HISTORIC PRESERVATION COMMISSION

ALTERATION TO A HISTORIC PROPERTY STAFF REPORT

Site: 24 Summer Street c. 1870 Odiorne-Langley House Case: (HPC 2015.034) Union Square Local Historic District

Legal Notice: Alter front entry including door and walkway; Alter driveway; Add wood fence and gate.

24 Summer Street front steps and walkway

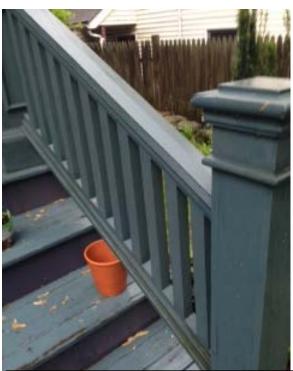
There is no fence. The driveway is asphalt; the walkway, cement; stairs and porch landing are brick. The door is a 1960s replacement. The brick steps and landing are in poor condition. See photos at the end of the document.
- Is the proposal more appropriate than the existing conditions?

- 1. The front door will be replaced by Vintage Door style G121.
- 2. The brick front porch and stairs with iron handrails shall be replaced by a new wood porch with new posts, railings, and balusters shall *exactly match those on the front of 45 Vinal Avenue in construction, size, shape, proportion, detail and material as per attached photo.*

- 3. The dimensions of the front porch shall match the existing of approximately 4' x 8'.
- 4. The skirt of the porch shall be wood.
- 5. The driveway shall have an apron of granite with real brick pavers in a pattern to be determined.

- 6. The walkway shall have real brick pavers to be determined.
- 7. The fence and gate shall be Charles and Concord as located in the site sketch provided by McDonough Fence dates 4/30/2015 and as shown on http://www.mcdonoughfence.com/wood.html
